S.S. N<sup>o</sup> 525.

Proposed alteration to Side Stringers  
Scale  $\frac{1}{2}$  = 1 Foot.

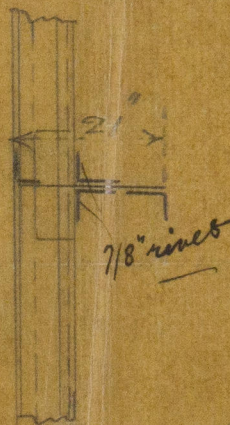
3 bars  $6 \times 4 \times \frac{12}{20}$  to  $\frac{11}{20}$   
in place of 4 bars  
 $6 \times 4 \times \frac{9}{20}$  to  $\frac{8}{20}$

as fitted  
CRB
